# Environmental Review Team Report

## Friland Property

Andover, Connecticut

April 1982

# Surficial Geology

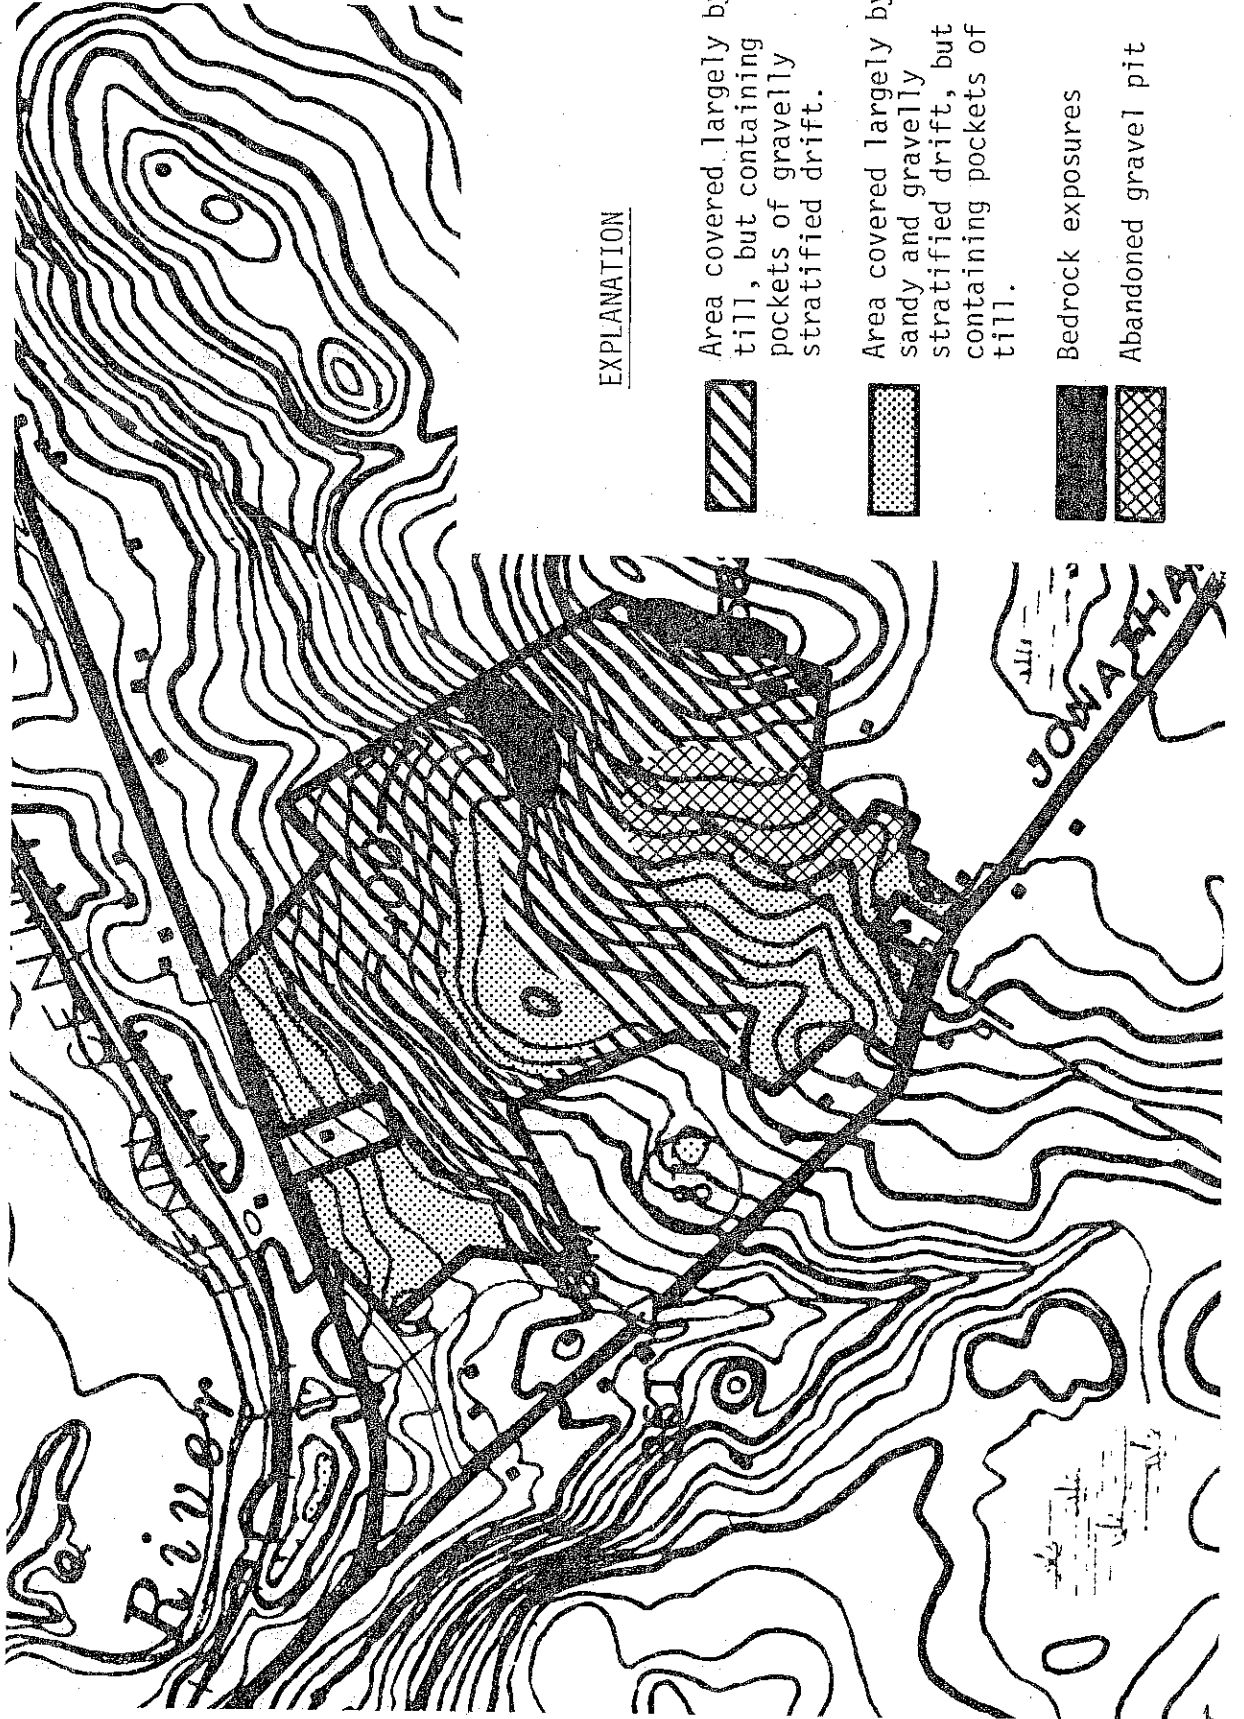
Stratified drift deposits in Connecticut are most commonly found in stream valleys, whereas till covers most of the upland areas. On this site, however, several bodies of stratified drift occur near the top or on the flank of the hill. Several mining operations for sand and gravel have taken place on the hill, exposing these deposits. Nevertheless, the principal overburden on the site seems to be till. Apparently, as the ice began to thin during glacial retreat, the hilltop was exposed while ice remained in the Hop River valley. Meltwater streams flowed along the edge of the ice or through fissures or holes in the ice. Patchy deposits of stratified drift were left on the hillside as the ice continued to waste down into the valley.

The result of this unusual pattern of deposition was the patchwork of till, stratified drift, and bedrock outcrops that makes up the site. It is clear, then, that the opportunities for specific developmental activities may vary considerably from point to point within the site. The southwestern portion of the parcel appears to have the greatest potential for development. Steep slopes, compact till, and rock are more limiting in the central and southeastern sections. A cluster development in the southwestern section, leaving the other sections undeveloped, would be more practical from a geological standpoint than a standard subdivision of the entire parcel.

# Vegetation

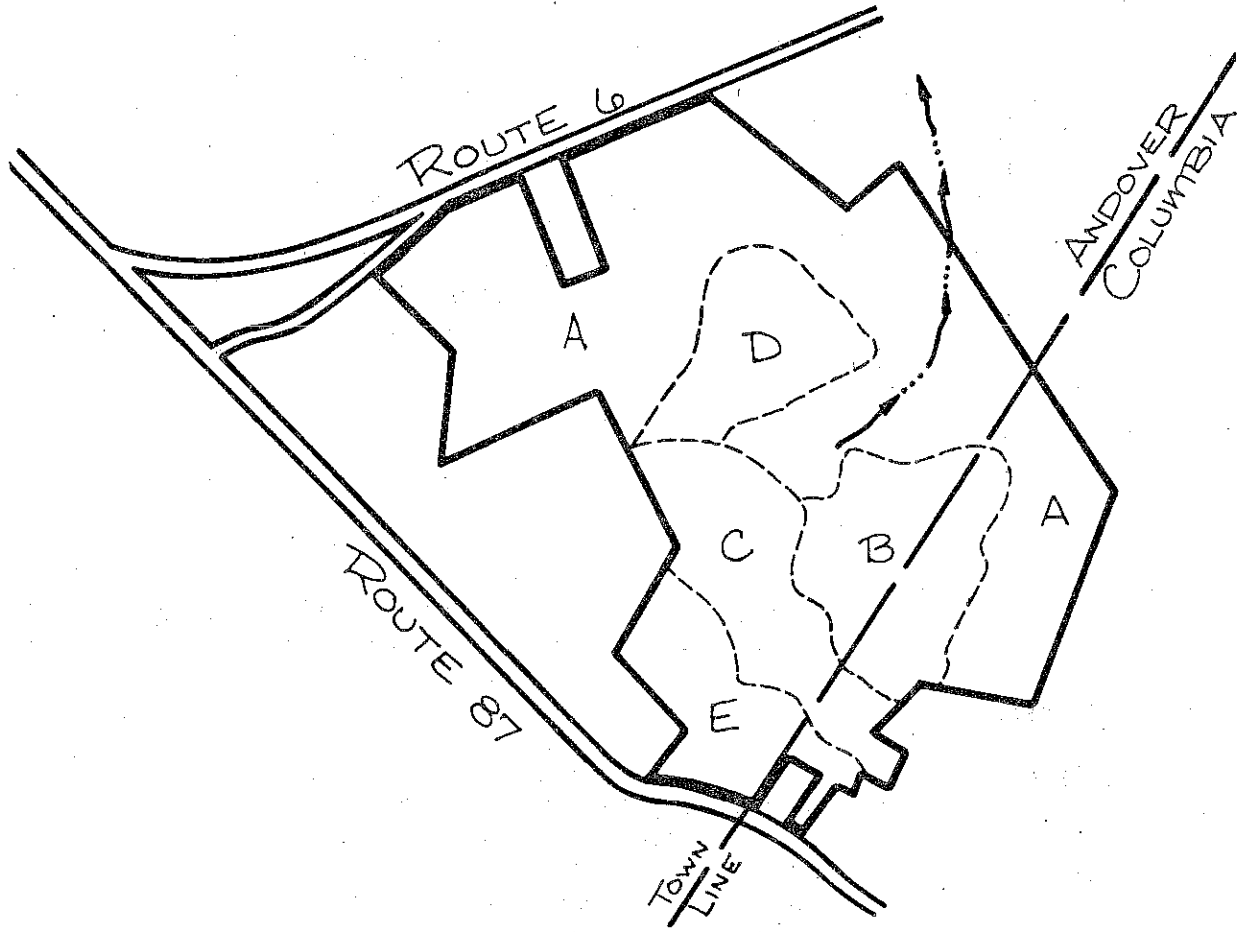
Large, healthy trees are a prime consideration for aesthetic value in and around residential areas. In Types A and D, large, healthy hardwoods and conifers should be retained to enhance aesthetics, especially along the stream. Type A, having been recently logged, would be improved aesthetically by the cleanup of tops. These tops can be utilized as fuelwood. Many cull trees which have no commercial value, due to cracks, seams, hollow trunks, large dead branches, and broken limbs can also be removed. These are often hazardous to personal safety. However, den trees which are utilized by wildlife should be retained. These are trees with openings at the base and useful holes for both birds and small mammals.

Type C is the only stand that is seasonally wet with a hardpan soil, rocks, and seasonally high water table. Any harvest should occur during extremely dry months or when frozen. This area may also be subject to windthrow. Any trees with lean, sprung roots or cracks are subject to uprooting or breakage in high winds and wet soil conditions. Type C and lower slope areas in Type A have this potential hazard. Type B, due to its exposed soil and patchy vegetation, displays erosion potential. This area and abandoned gravel pits can be reclaimed by planting forest seedling stock, such as white pine and larch. This material can be planted in April. Spacing of seedlings can be 8' x 8' or 10' x 10'. Grasses and hardwood vegetation may seed in naturally, but prompt soil stabilization is better to minimize erosion and sedimentation. The Soil Conservation Service can offer more detailed advice as needed.

Type A has been logged within the past year of about two-thirds of the total volume on the land. However, this stand is still somewhat crowded (too many trees/acre). The stand is mostly pole-sized trees that are healthy with some scattered cull trees. Removal of the culls would improve aesthetics and reduce hazards as well as give additional sunlight to improve growth on the existing healthy pole trees. In addition to cull removal, tops from the harvested trees should be removed for use as fuelwood.

In Type D, retain all the large white pine. The hardwood poles in the understory contain eight-ten cords/acre and can be removed for fuelwood. This will favor the young white pine regeneration, provide wildlife food from stump sprouts and help to promote species diversity on the property as a buffer against insect and disease attack.

Type C is a fully stocked pole stand which is crowded. There are approximately twenty cords/acre in fuelwood sized trees. Of these, six cords/acre can be removed, taking the poorest trees or the most undesirable one-third of the trees. This will reduce crowding, remove the poorest growing stock, and promote the best trees for future growth. White ash can be favored over sugar maple, and yellow birch over red maple. This area has seasonal limitations on harvesting due to wetness. Operations should be restricted to August through February.

TRAFFIC SAFETY: SIGHT DISTANCES\*

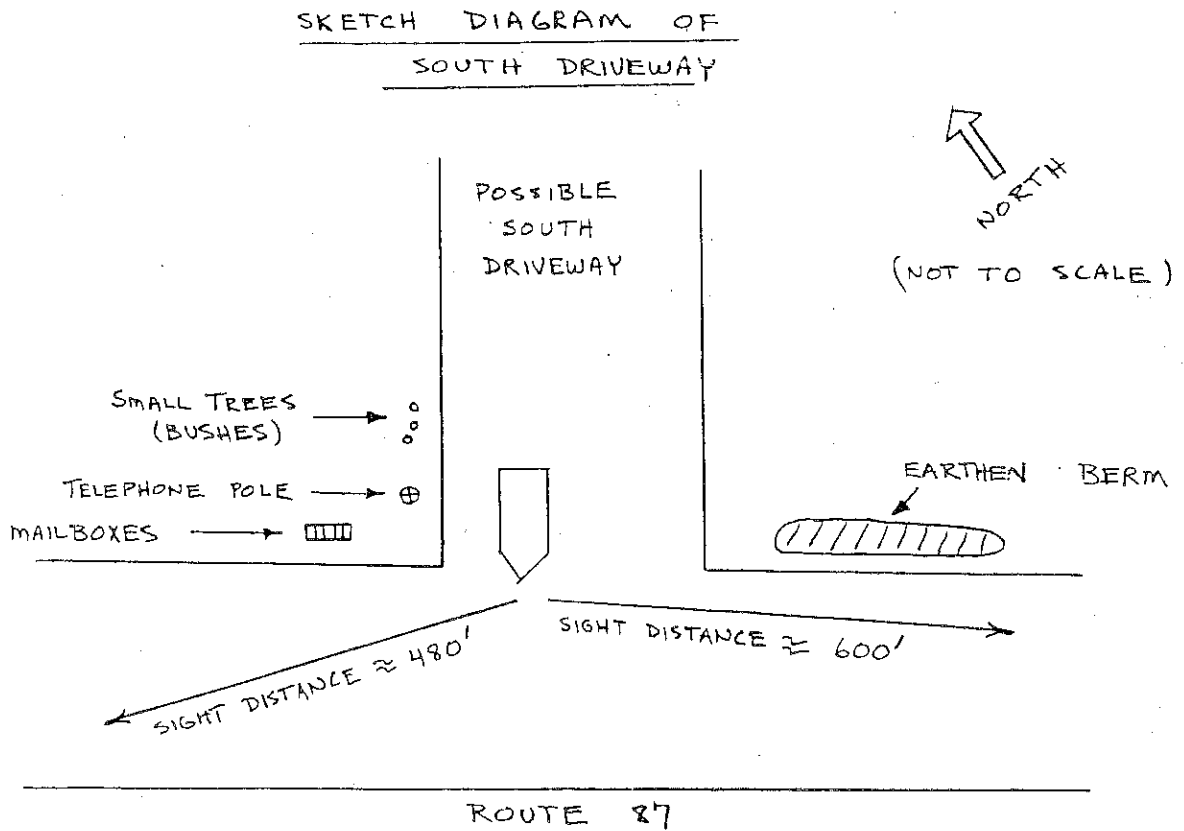
In general, the sight distance from the south driveway location is adequate. However, minor improvements should be made if a driveway is placed at this location. It is recommended that the berm on the south side of the driveway be reduced or eliminated. The berm is very close to Route 87 and forces drivers leaving the site to drive their cars close to the travel lane of Route 87 in order to observe traffic northbound on Route 87. With this minor improvement, drivers should be able to observe oncoming northbound traffic up to 600 feet away without encroaching on the pavement of Route 87.

On the north side of the drive, some mailboxes, a telephone pole and a few small trees (bushes) are minor obstructions to sight distance. The trees should be removed and, if possible, the mailboxes should be relocated.

Sight distance at the north driveway location is inadequate. The possible driveway location is on a section of Route 87 that has both a relatively steep grade and sharp curve (horizontal curvature). It is recommended that a driveway not be constructed at this location.

No measurements were taken at the northern driveway location, but based on visual observations it was concluded that sight distance at that location was inadequate.

Soils

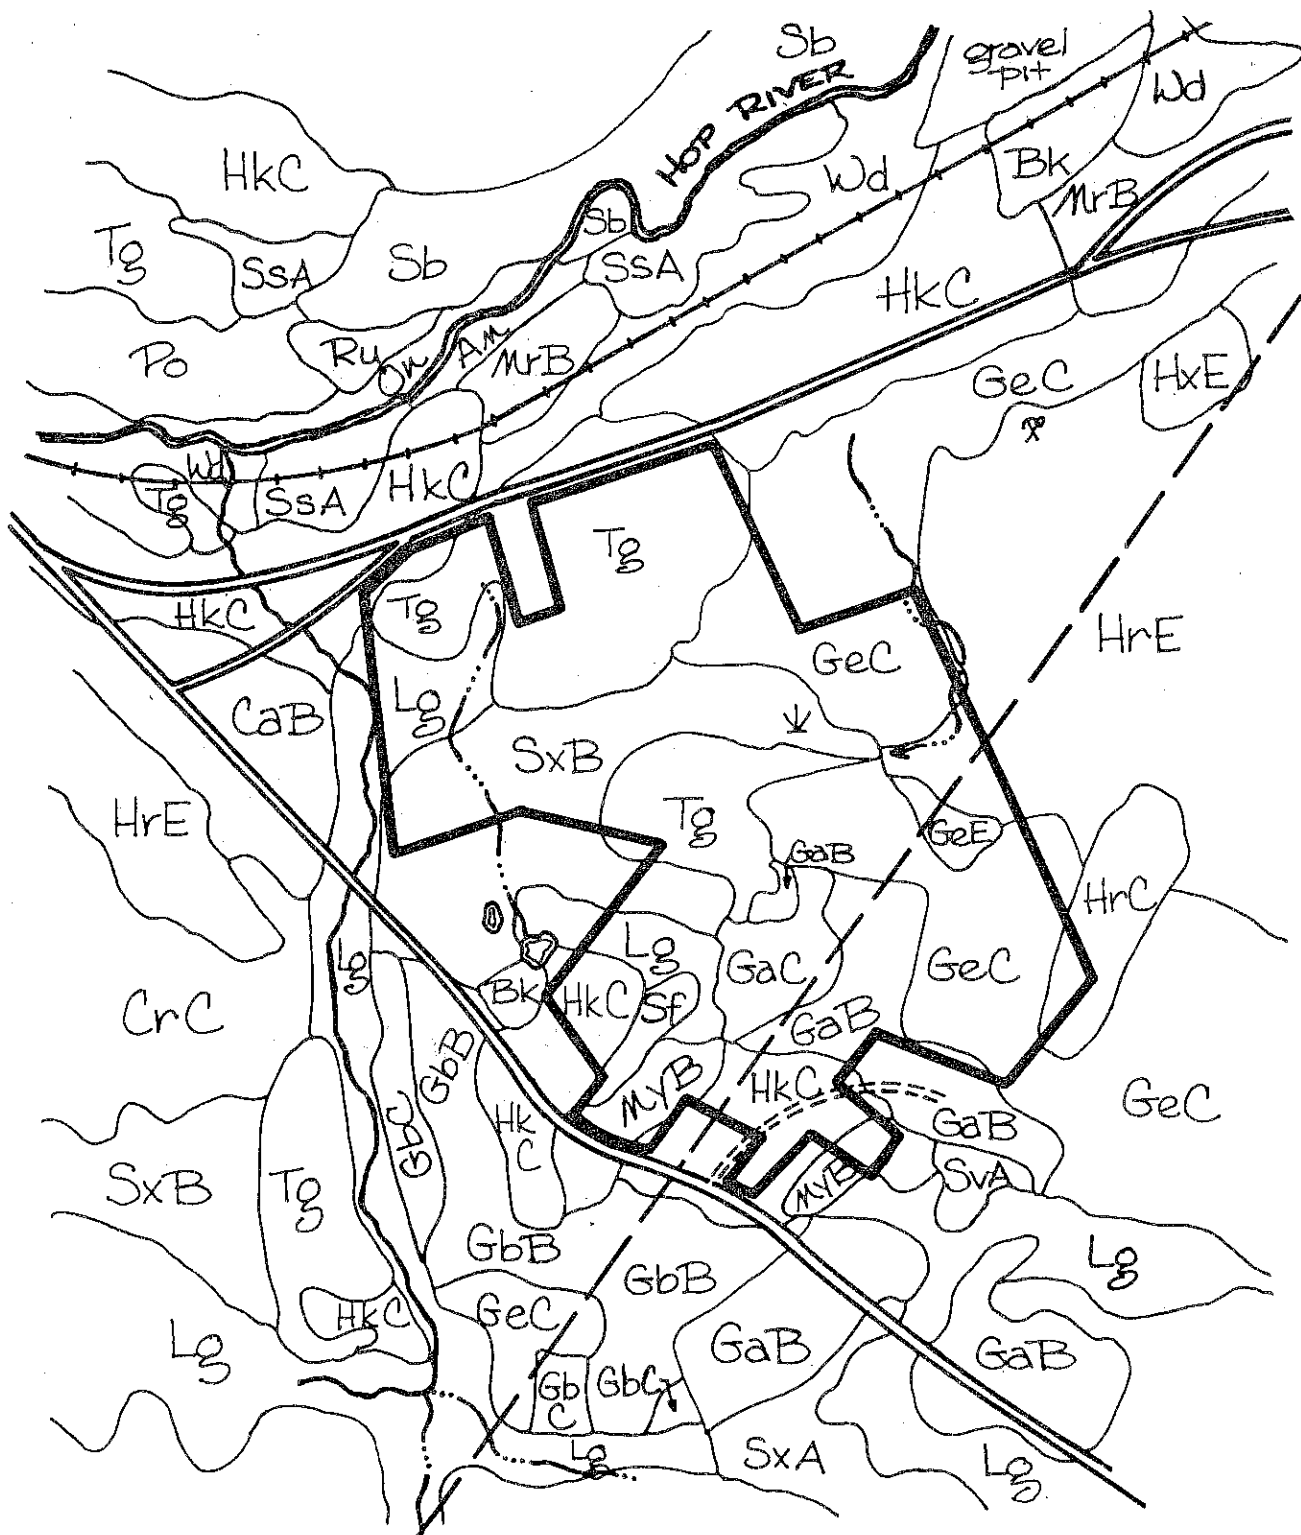
Because of the complexity of the site and the intensive development proposed, a detailed soil survey should be prepared by a private soils consultant. This information should be used in planning housing location and layout, road construction and on-site sewage disposal area. The map should also locate wetland and watercourses and can be used to identify potential pond sites and critical areas that need special treatment or protection during the development process.

With careful planning, this site has the capability to support residential development. The density and number of units would depend on the conditions revealed by on-site investigations and locations of on-site sewage disposal areas and water supply. Because of site conditions, clustered residential development appears to be the more appropriate alternative for the site.
